FIELD REPORT – LYNNWOOD RECREATION CENTER – FIELD REPORT

REPORT #05

Job No. 10-100622B1

Location(s) of Work: Natatorium roof.

Overview of the Natatorium Roof taken facing southeast.

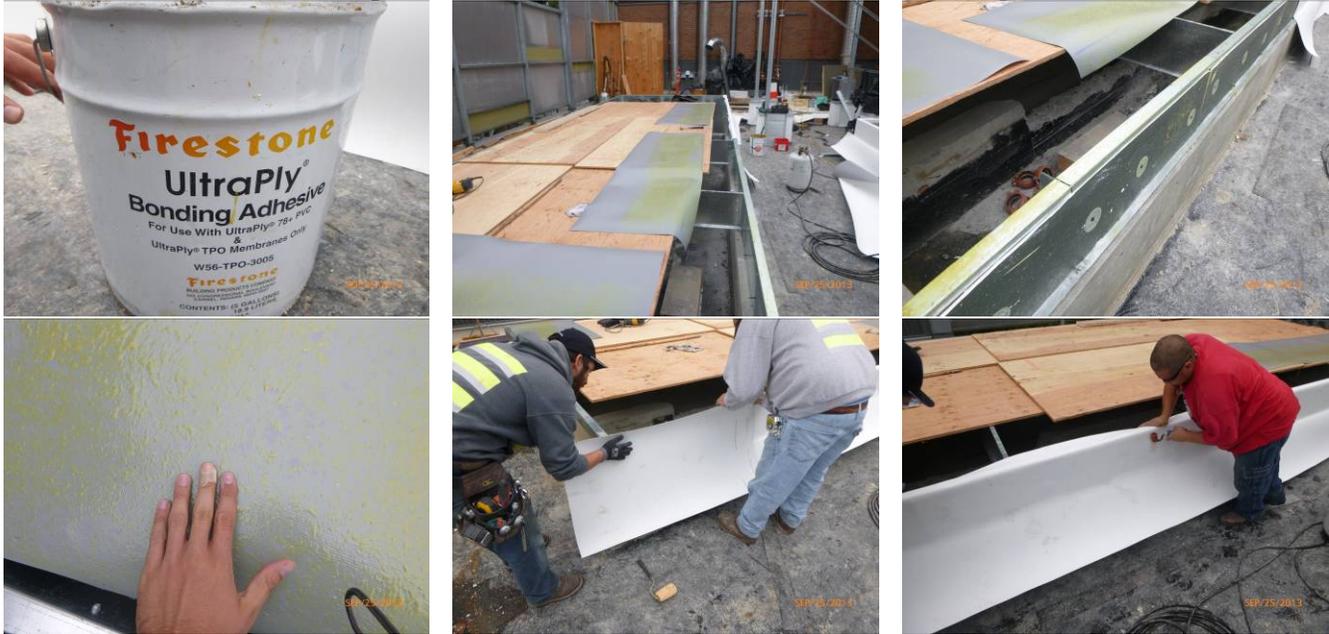
- 5.1 Delta Construction is installing unistrut supports for the new HVAC ductwork at the Natatorium Roof. Queen City Roofing is installing TPO baseflashing onto the upper half of the new HVAC curbs.

Continued from Item 5.2b on the previous page.

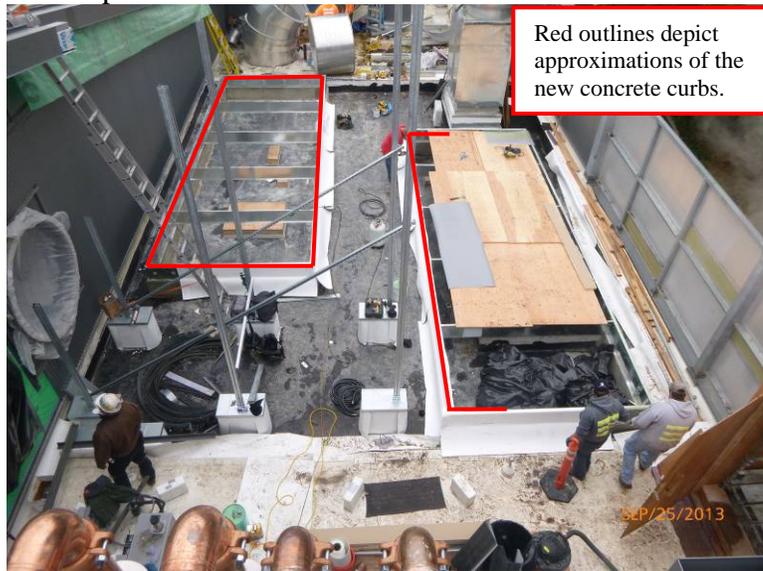
5.2b The seams in the upper half of the baseflashing membrane are welded utilizing a hand-held hot air welder and silicone roller to promote adhesion. Corners are welded on the inside with the membrane turning approximately 2-inches down into the interior of the curb. No labels are observed for the Firestone TPO membrane on site at this time.

CASC Roof Progress Plan / Locator Map:

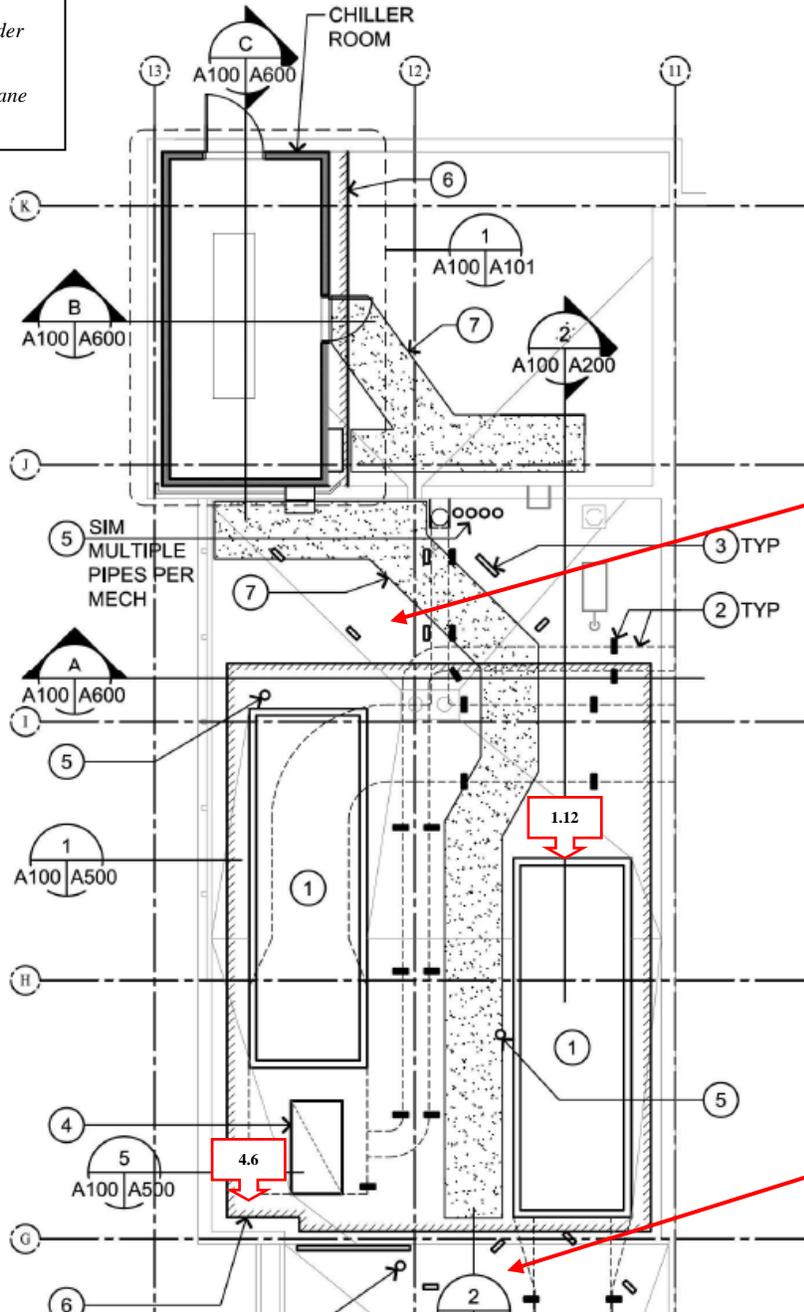
North of this line (approx.) the remainder of the Natatorium roof is wet and damaged as an existing condition.

Recommend verifying the presence of a vapor retarder layer over the deck south of Natatorium Roof.
